# API Standard 53

# Deviations from API 53

Typical Stack Today

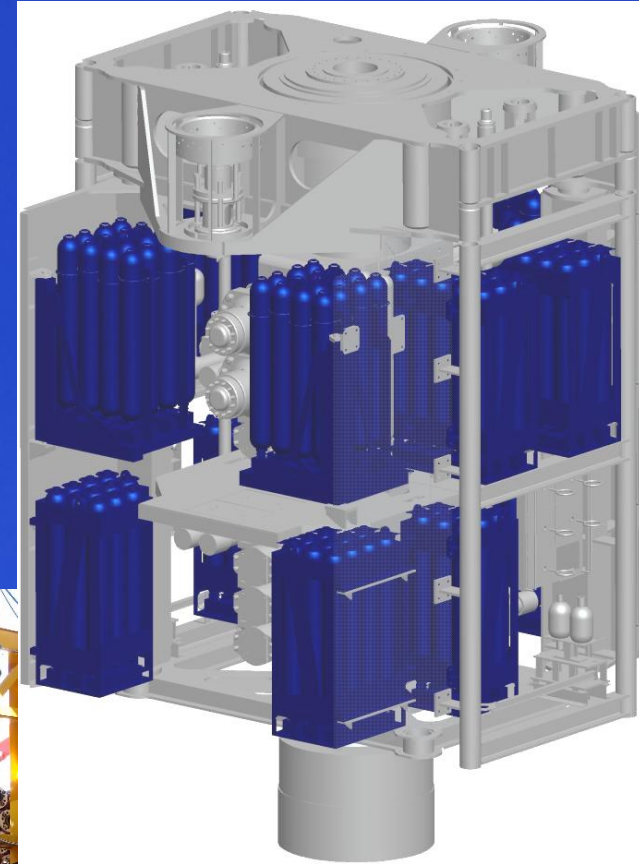
To comply with proposed rule,  
one Drilling Contractor's stack  
would require :

- 33 additional subsea accumulators
- 62 Surface accumulators
- 19 additional ROV panels

However, it is currently in  
compliance with API specifications.

Stack After Proposed Rule

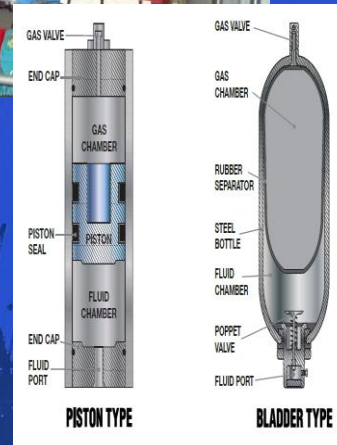
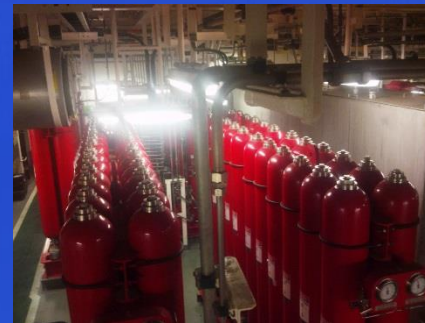
After the proposed rule, BOP Stacks would be significantly heavier, more difficult to handle and maintain, and have ROV visibility obscured. More importantly, they would not be any safer than the ones used today and would become less reliable due to the additional components and leak points.

## Hydraulic Power Unit

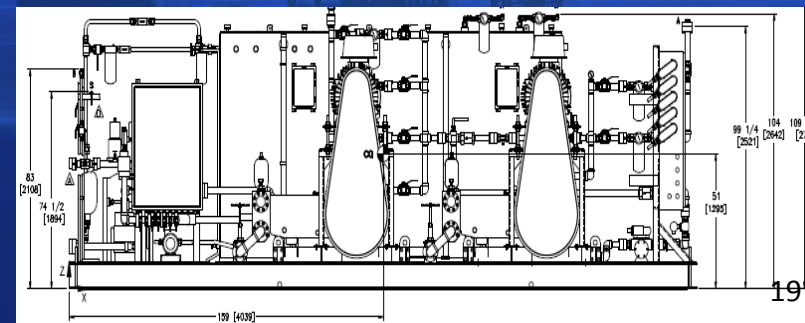
Accumulators store energy for use when power source is unavailable or to assist rapid discharge. Basically they compress gas against the power fluid which expands and drives the power fluid to the selected application. All BOP functions are normally powered from surface supply by high pressure pumps that deliver fluid which is stored in accumulator banks which supplement the pumps when a function is operated such as closing a pipe ram.

250.735(a) A surface accumulator system that provides 1.5 times the volume of fluid capacity necessary to close and hold closed all BOP components against MASP.

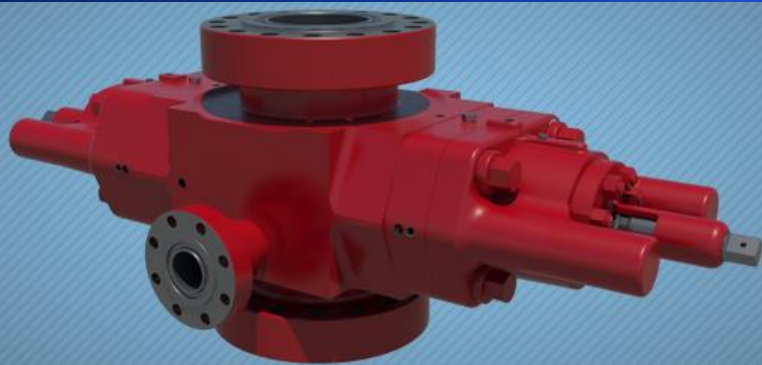
A complete breakdown and detailed physical inspection of the BOP and every associated system and component must be performed every 5 years. This complete breakdown and inspection may not be performed in phased intervals. A BSEE-approved verification organization is required to be present during the inspection

***Are all these associated systems to be removed and returned to OEM every 5 years?***

BOP with Manual Locks

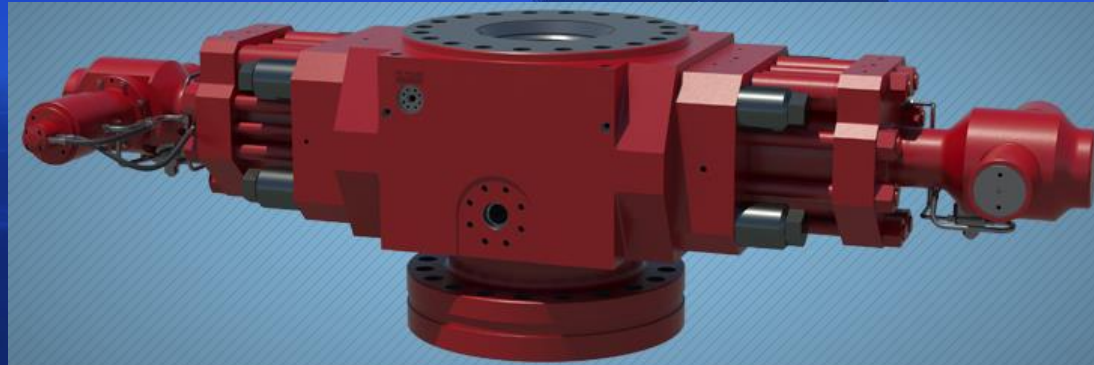
- Manual locks have been reliably and safely used for many years
- The need for hydraulic locks was driven by the application of a subsea BOP which doesn't lend itself to manual locks as it is physically located subsea
- During the latest revision of API 53, there was insufficient data to require the use of hydraulic locks on surface BOPs
- Manual locks are more reliable than hydraulic locks due to their simplified design and inherent manual operation
- Increase in control system complexity
- Operating the equipment under high pressure has successfully been accomplished using proven safe operational procedures
